PRODUCT CHANGE NOTIFICATION

Bourns® CW201212, PM0805, CW252016, and PM1008 Series High Q Chip Inductors

Ink Supplier Change

IC25133

Existing Marking

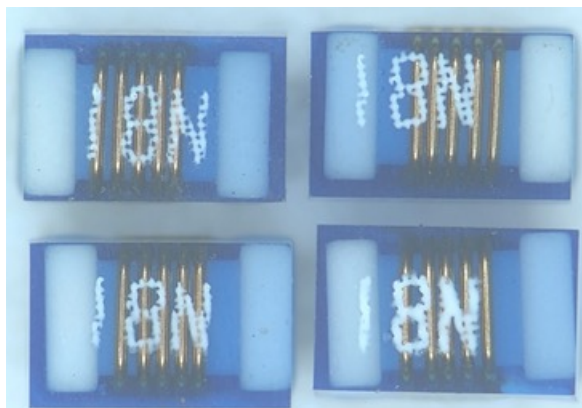
As shown in the image above, the form of the affected part numbers will change slightly due to the change in marking ink. The fit, function, quality, and reliability of the inductors will not be affected by the change. Traceability will be maintained through lot code and date code.
